From: Orenak, Michael
Sent: Friday, May 20, 2022 3:32 PM
To: michael.tschiltz@gmail.com; AAFZALI@southernco.com
Subject: NRC initial comments on TIRICE white paper
Attachments: NRC initial comments for TIRICE Project White Paper Rev A 5-20-22.docx

**Technology Inclusive Risk Informed Change Evaluation (TIRICE)
For Non-Light Water Reactors**

**Change Control Scope and Process
For a Reactor Licensed in Accordance with the NEI 18-04 Guidance**

Document Number
SC-16166-107
Revision A

Figure 1. 10 CFR 50.59 Process for a Reactor with an LMP-based Affirmative Safety Case

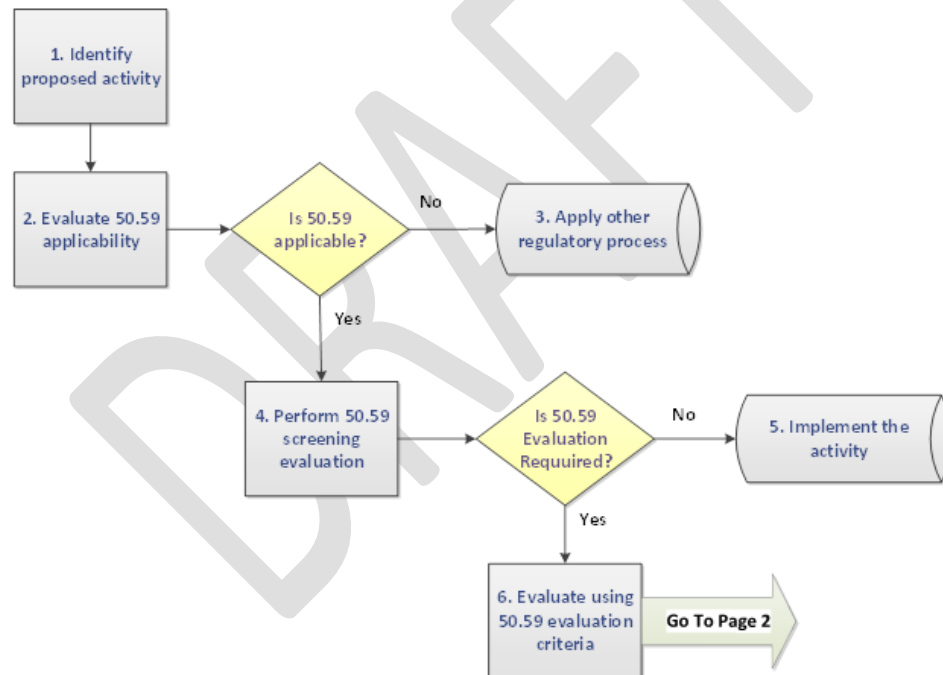
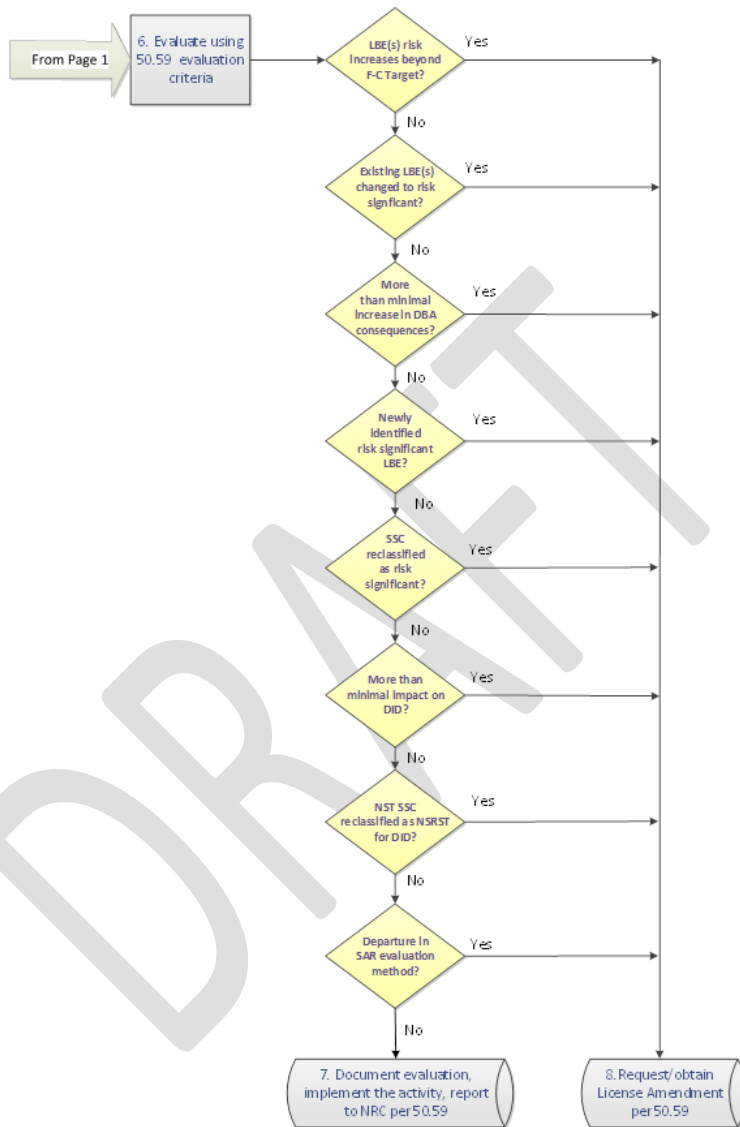
Commented [A40]: This portion of the figure should better align Figure 1 in NEI 96-07
